RENESAS TECHNICAL UPDATE

Product Category	MPU & MCU		Document No.	TN-16C-A223A/E	Rev.	1.00
Title	Errata to R32C/116 Group User's Manual: Hardware		Information Category	Technical Notification		
Applicable Product	R32C/116 Group	Lot No.	Reference Document	R32C/116 Group User's Manual: Hardware Rev. 1.10 (REJ09B0532-0110)

This document describes corrections to the R32C/116 Group User's Manual: Hardware, Rev. 1.10. The corrections are indicated in red in the list below.

Figure 8.1 Clock Generation Circuitry

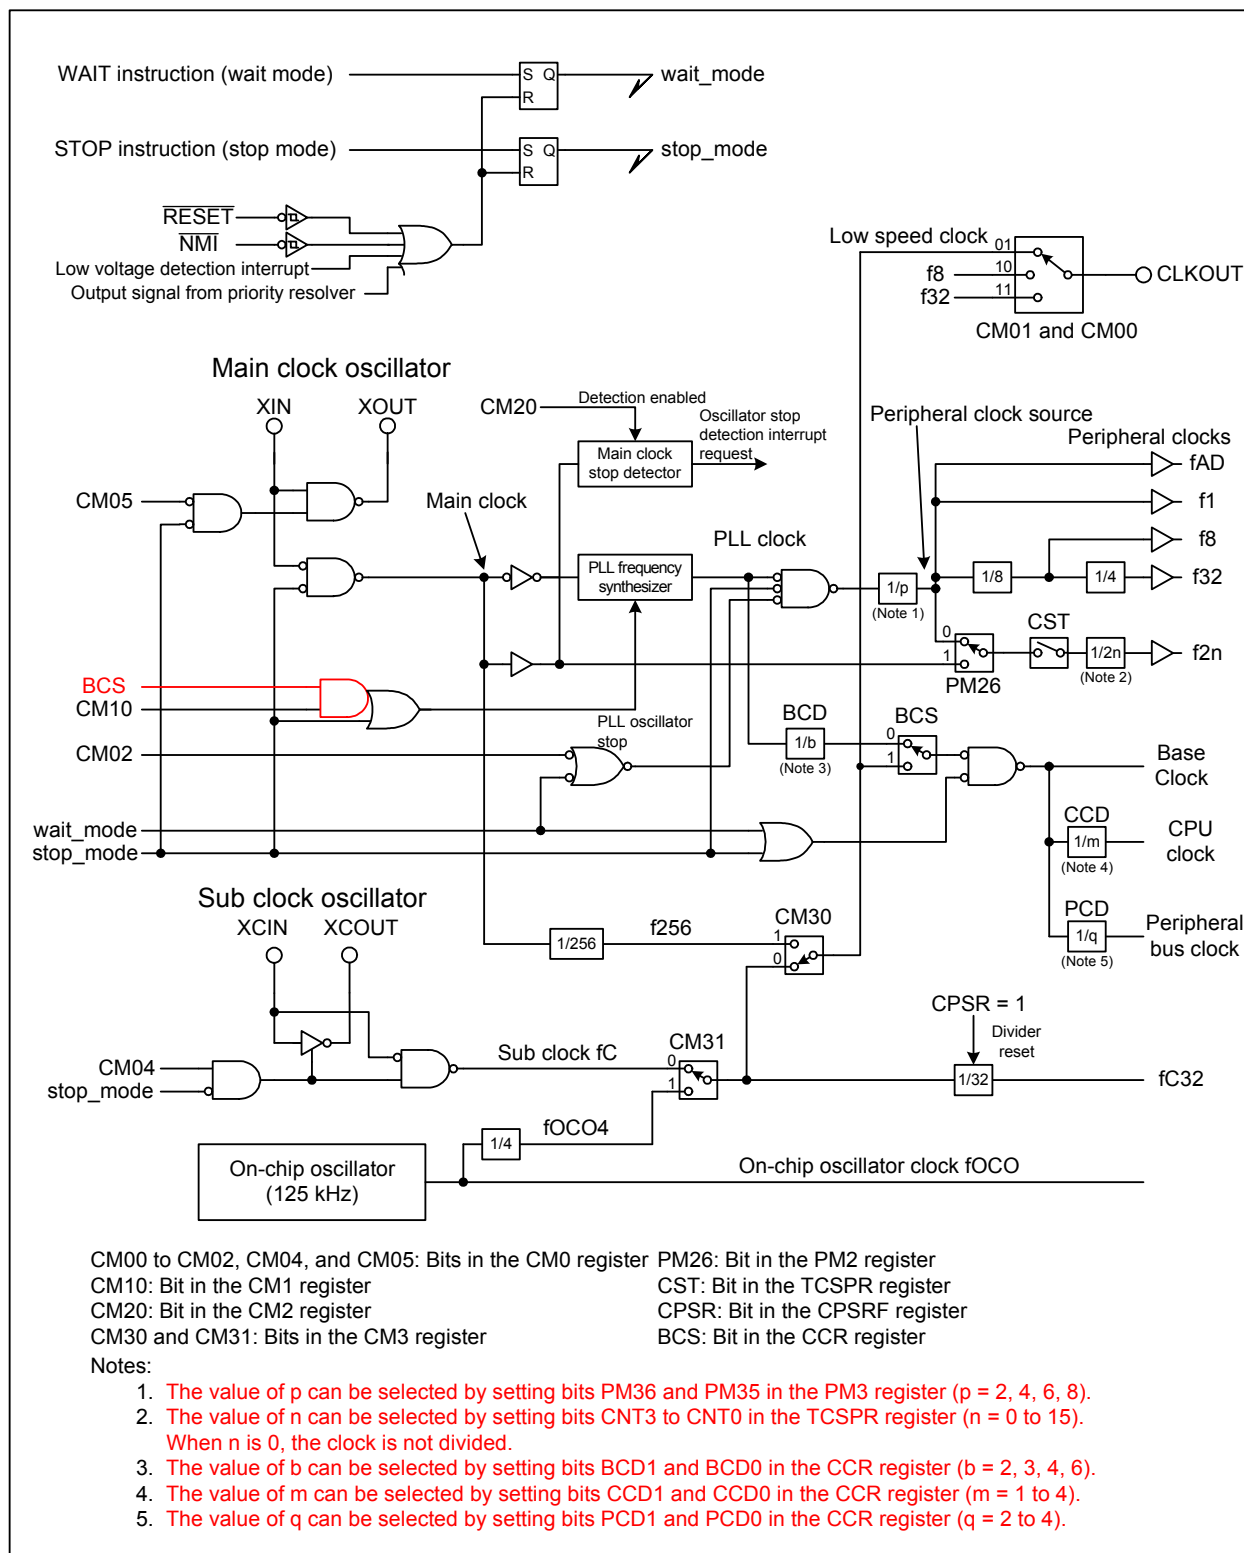
•Page 69 of 520, Figure 8.1 is corrected as follows:

Figure 21.1 CRC Calculator Block Diagram

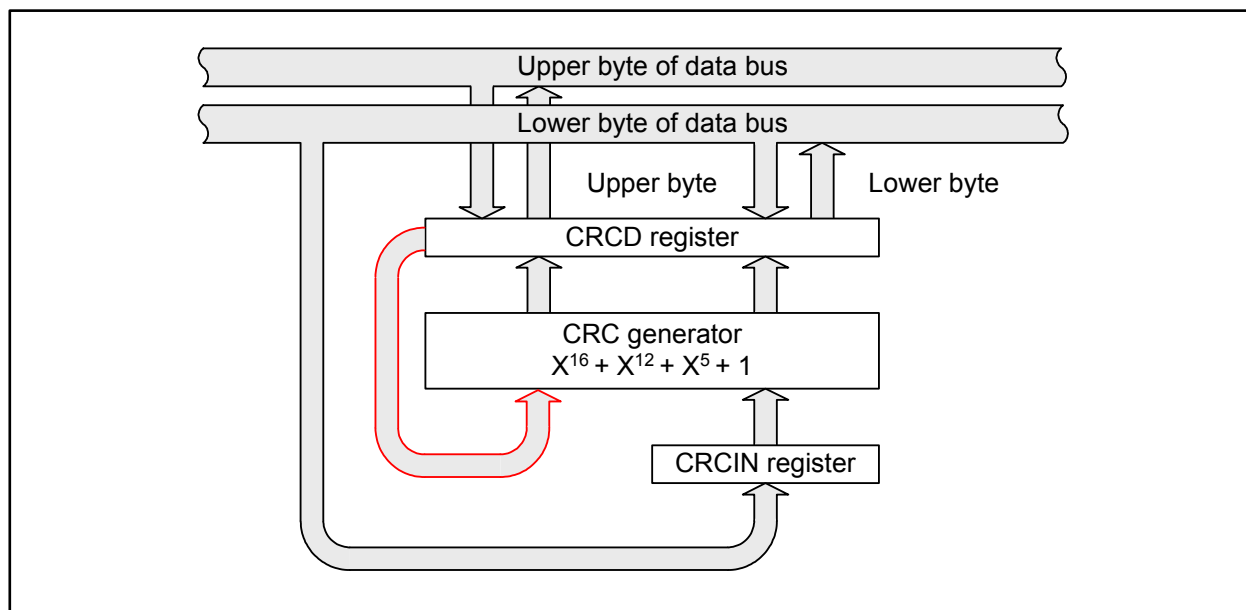
- Page 308 of 520, Figure 21.1 is corrected as follows:

Figure 25.1 Typical I/O Pin Block Diagram (i = 0 to 15; j = 0 to 7)

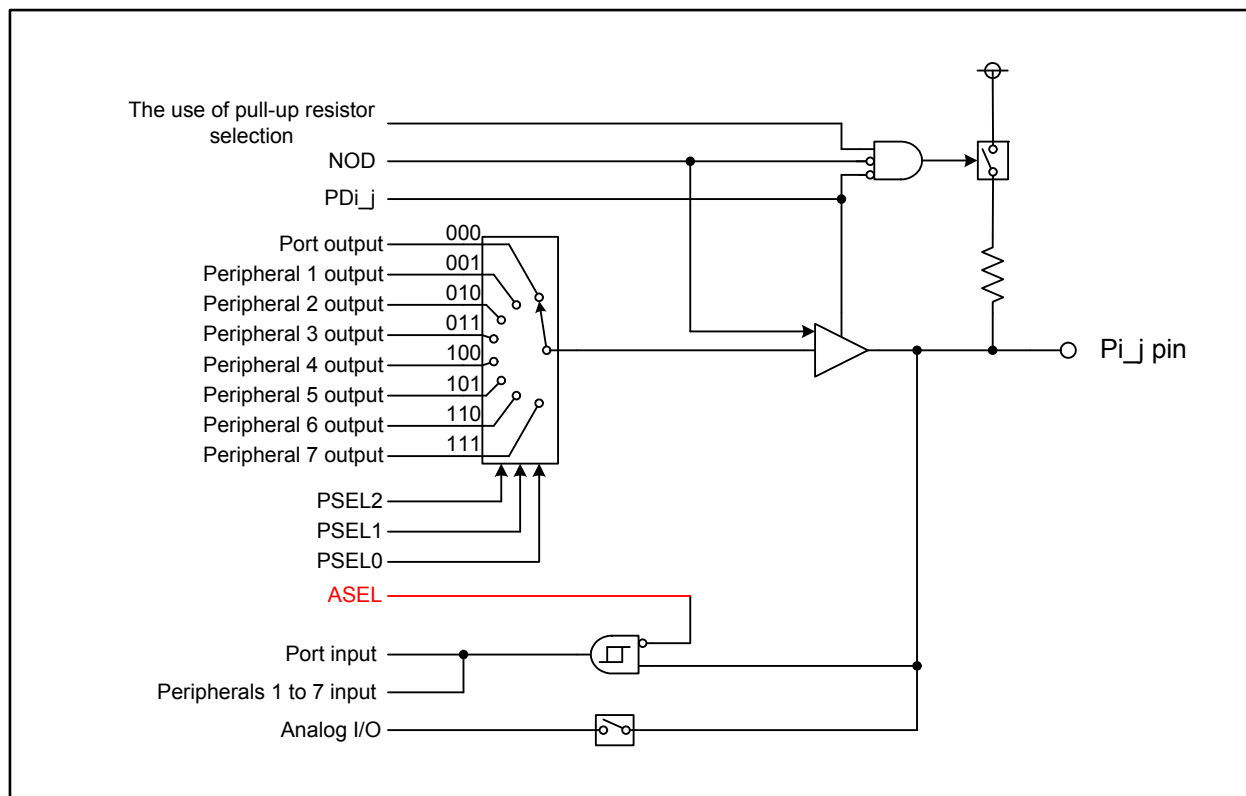
- Page 393 of 520, Figure 25.1 is corrected as follows (refer to TN-16C-A200A/E):
